Profile No	Problem	teaching Result			
	<p>This Area, Bearing undercut is not good enough, Profile is blocked because undercut is too close to the bearings You need to give more Attention at the finishing workingplace!</p>	<table border="1"> <tr> <td></td> <td></td> <td></td> </tr> </table>

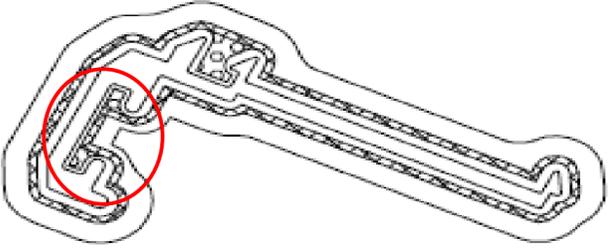
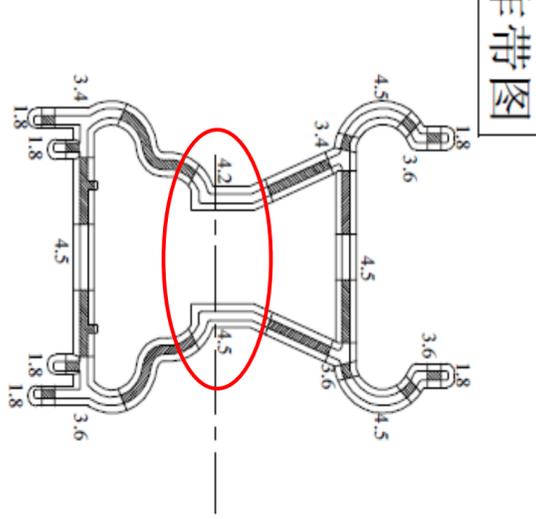
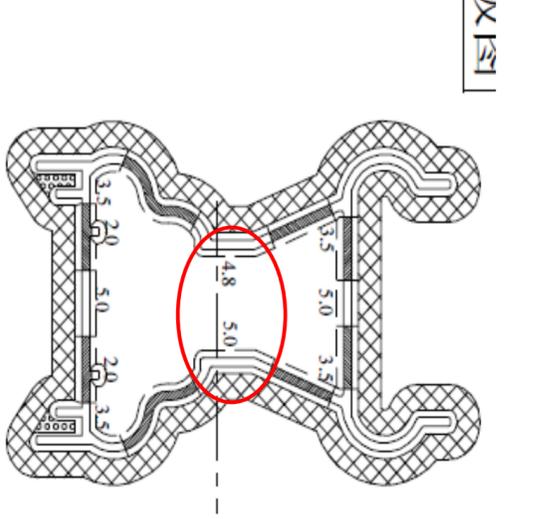
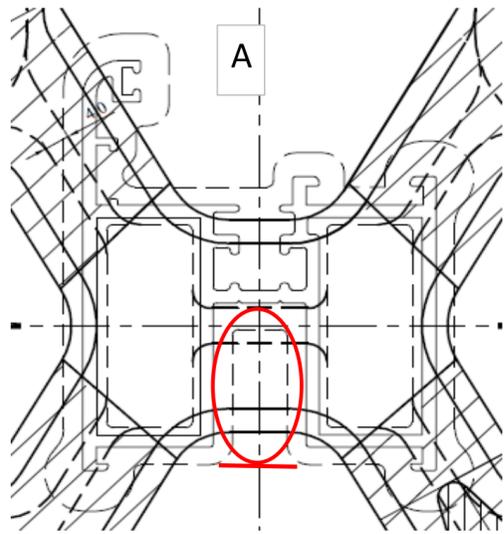
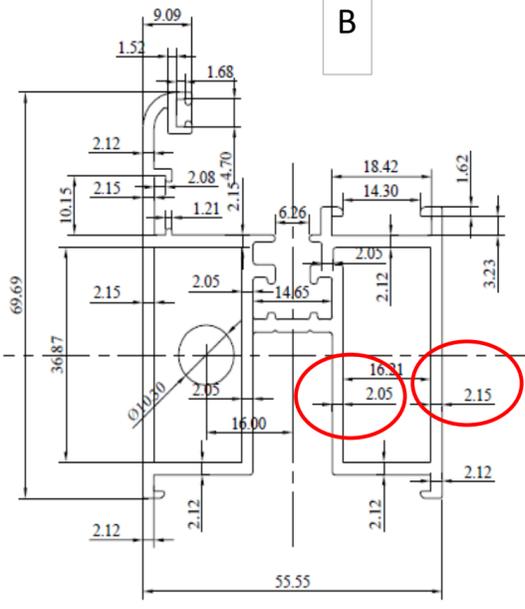
<p>Mandrel Bearing length in this Area could be a 0,5mm shorter</p> <p>Profile is in Tolerance but a little small the open Area</p>
--	---	---

<p>A: 2nd Step milling down this Area, because the open is too small</p> <p>B: Wall thicknes difference max. 0,05mm, because the Mandrel is very stabil with this design</p>
---	--	--

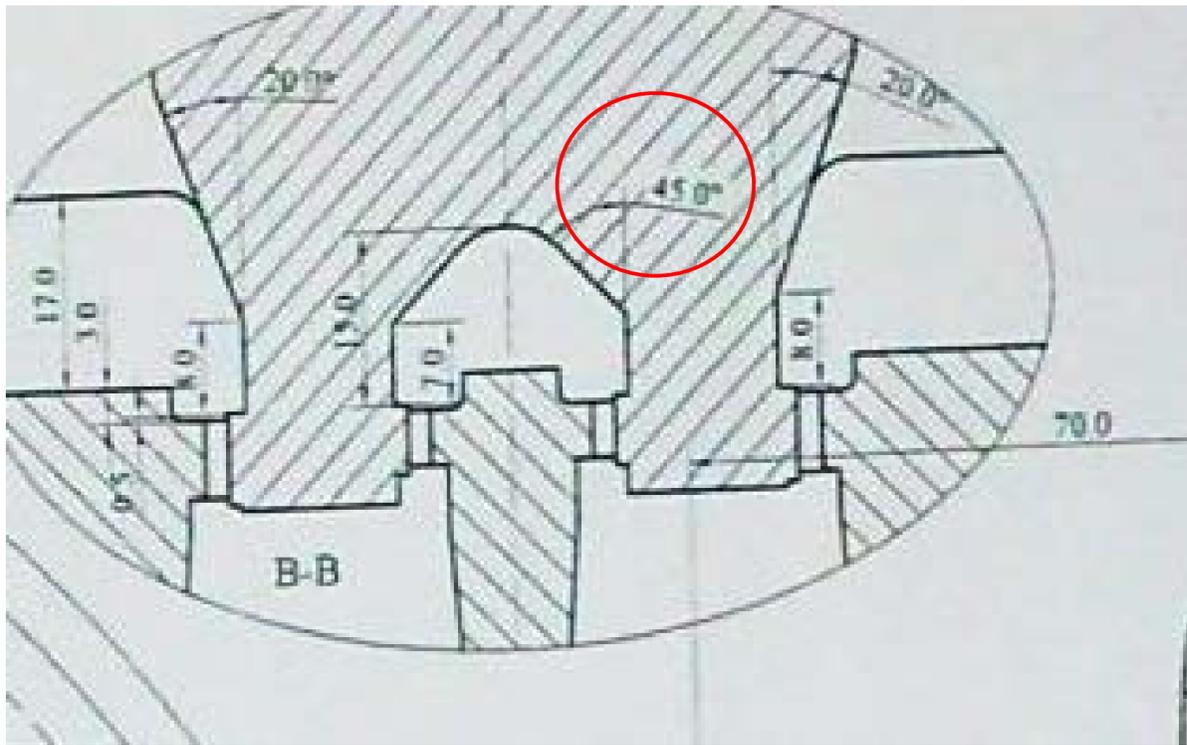
No sharp edges!!
No good support
so the Mandrel
can move!

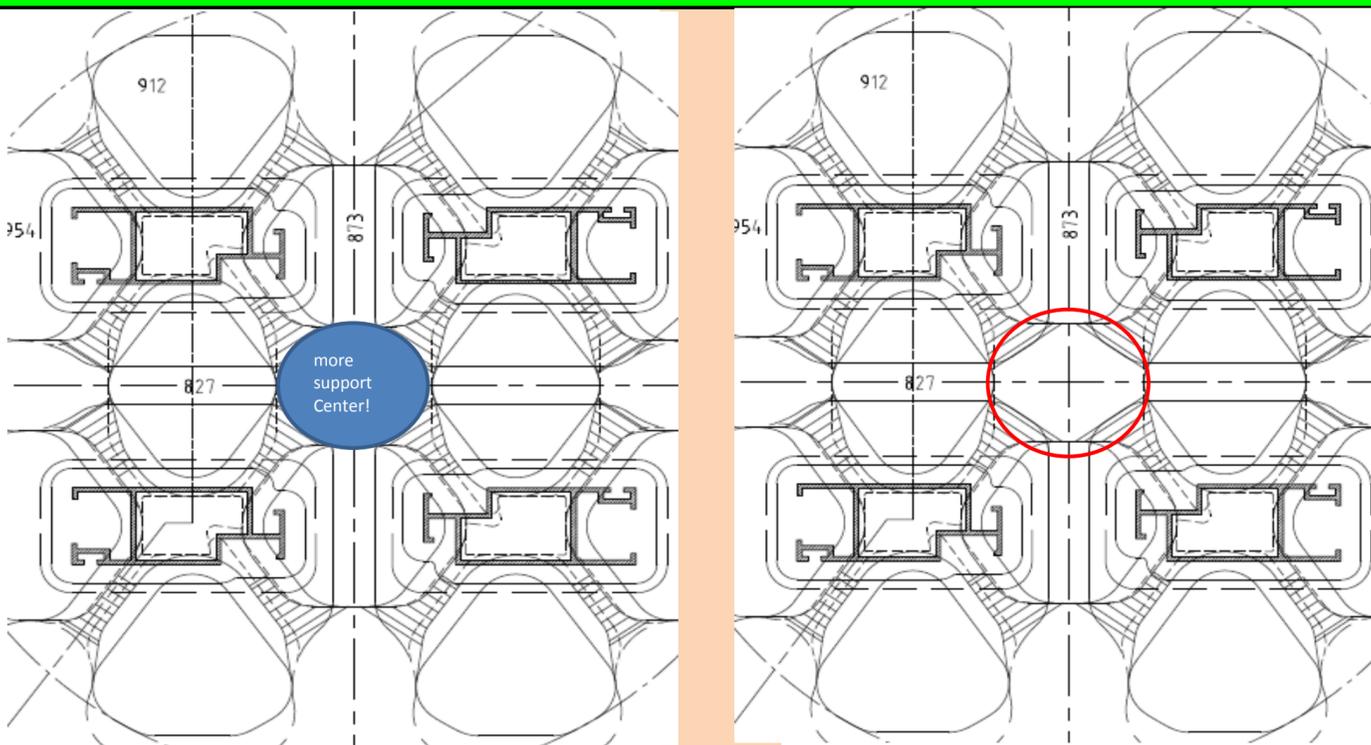
Between two
Mandrel work with
an Angle to better
control the Mandrel
moves.

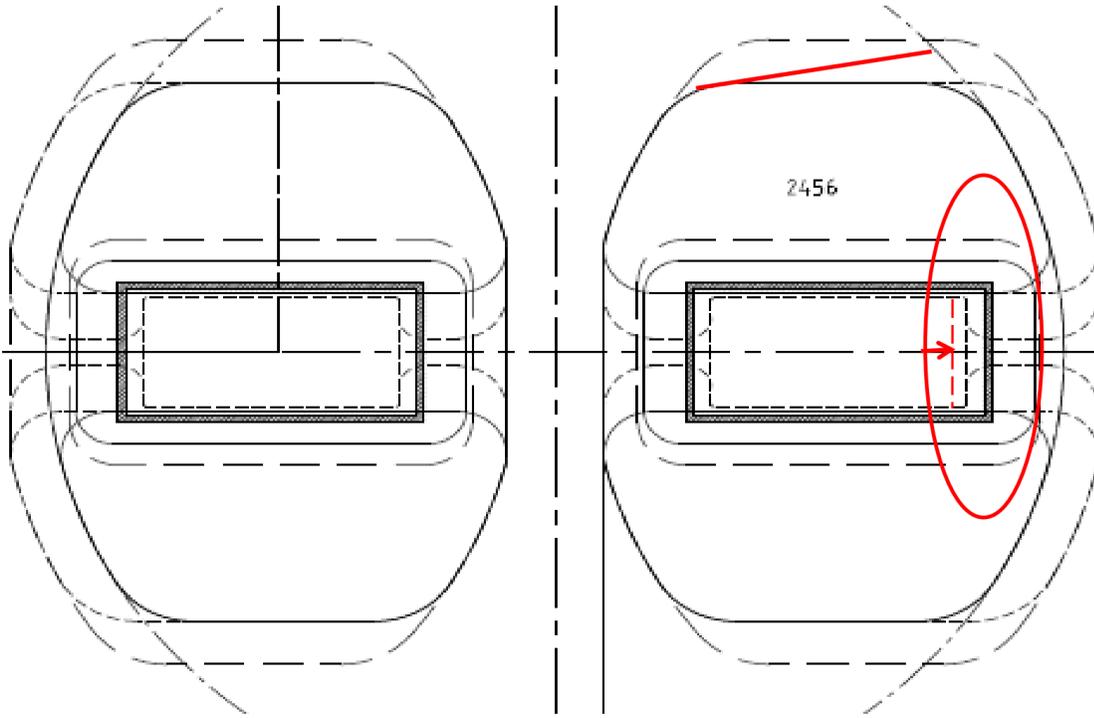
No good Example
Center part needs
best support!!!

No good Example:
Not respect the different flow from Center to outside, also not respect the deflexion

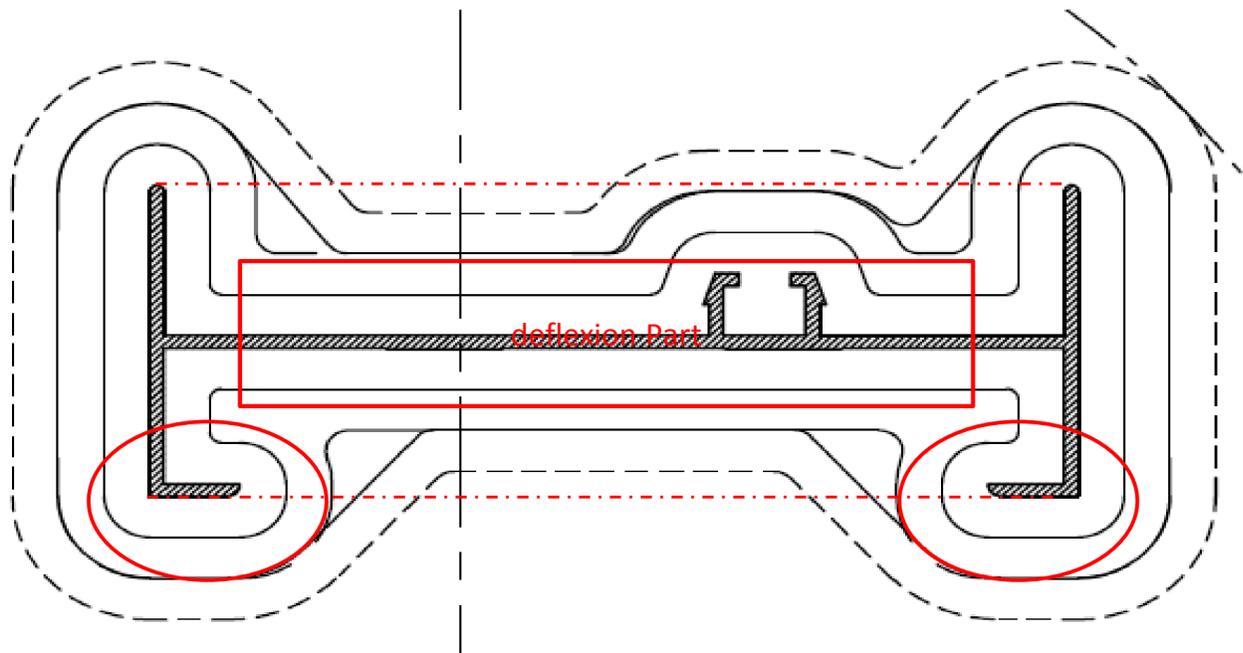
1. outside a little more undercut (0,5mm)
2. Open the Inlaid to outside

No good precamber Area at the small parts should be enlarged!

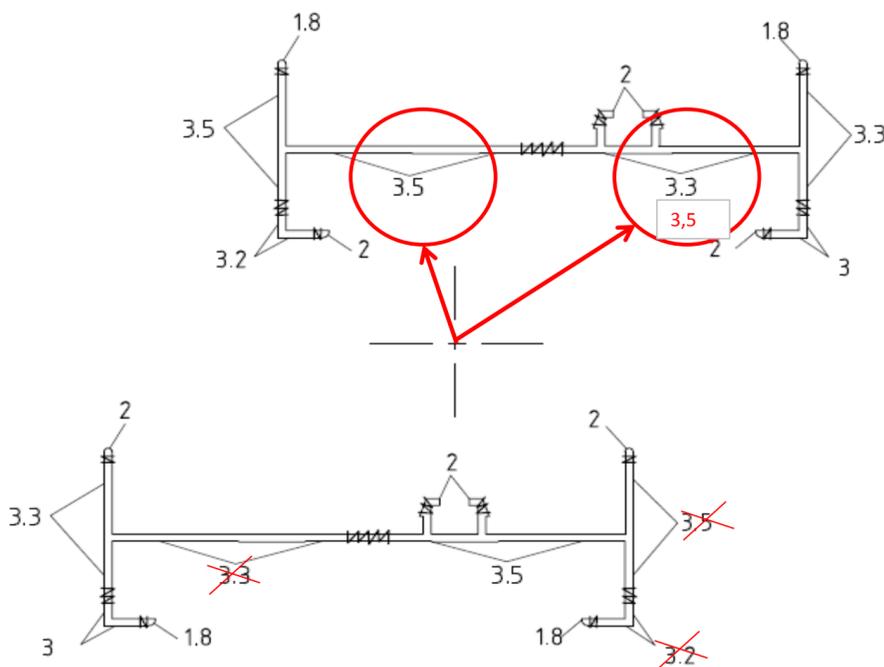
Also between the deflexion part ----- the bearings should be longer.

No good different bearing length, should make the difference in the Volume of the Inlaid Port.

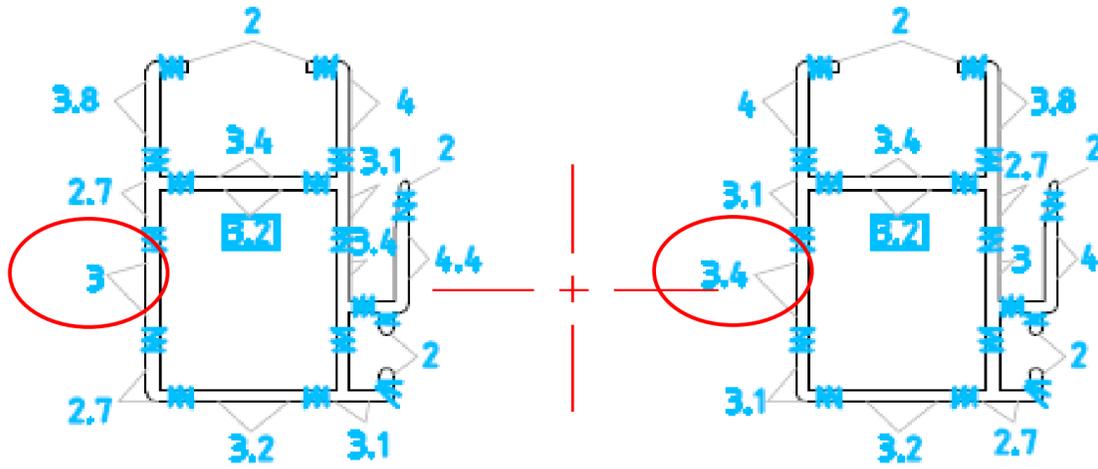
- shorter the bearings only for Correction

In Die design make no difference at the bearing length from inside to outside, this should be only for Correction

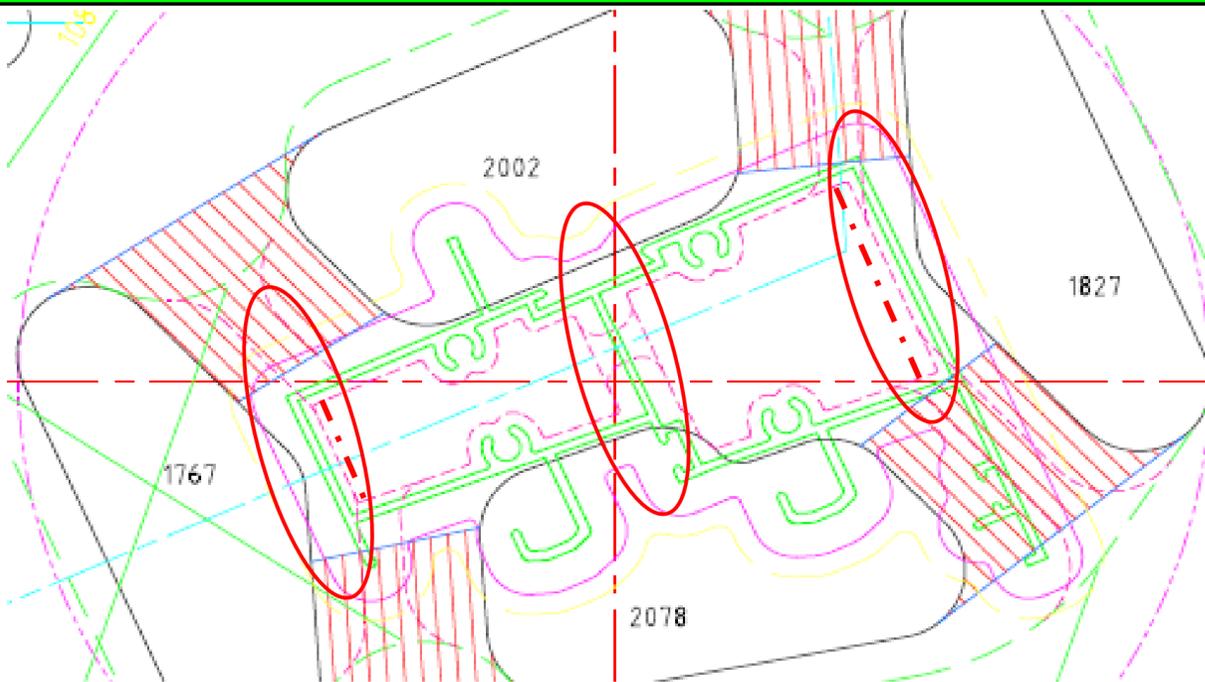
You have to increase the Volume outside!

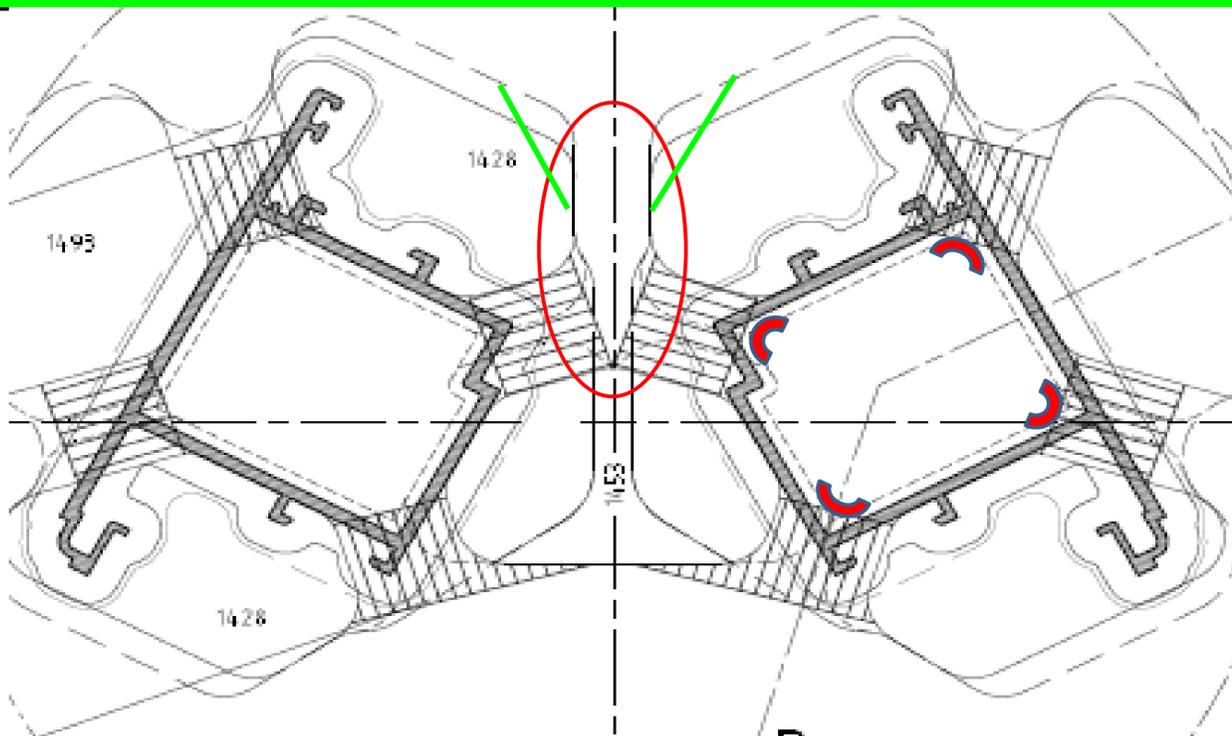
Undercut of Mandrel should be the same, or outside a little more!

Middle Part to small so no support for the Mandrel at the Die Plate!! Reason for Mandrel deflexion!

The green lines shows how to do it better!

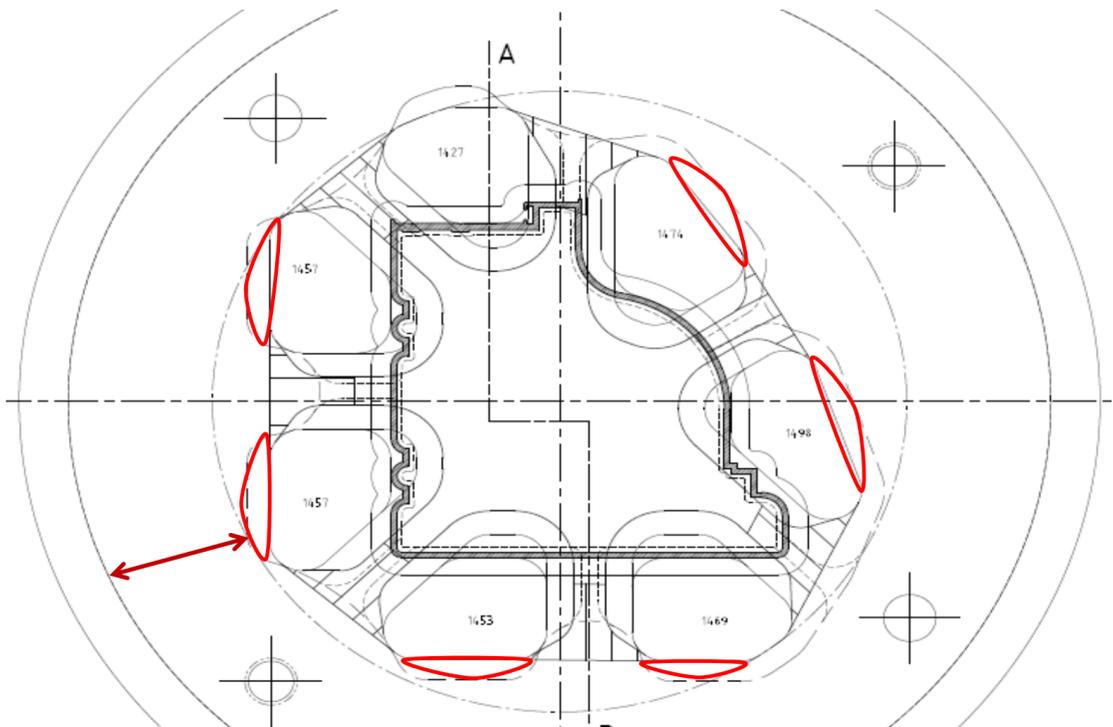
Mandrel undercut at the Edges should be a Radius >R2 -R5, because the bad flow

<p>The drawing shows a cross-section of a mechanical part with a complex internal profile. A large circular area is defined by a dashed line, representing the mandrel area. Several red ovals highlight specific regions within this area, and a red arrow points to one of them. The drawing includes various dimension lines and labels: 'A' at the top, 'F119' on the left, and part numbers 1427, 1457, 1474, 1498, 1453, and 1469. There are also four circular symbols with crosshairs, likely representing hole locations or reference points.</p>	<p>Big Mandrel Area, so it means we should use a bigger Die Size! (more than 20% of Diameter)</p> <p>We always should try to use the maximum Inlaid!</p>
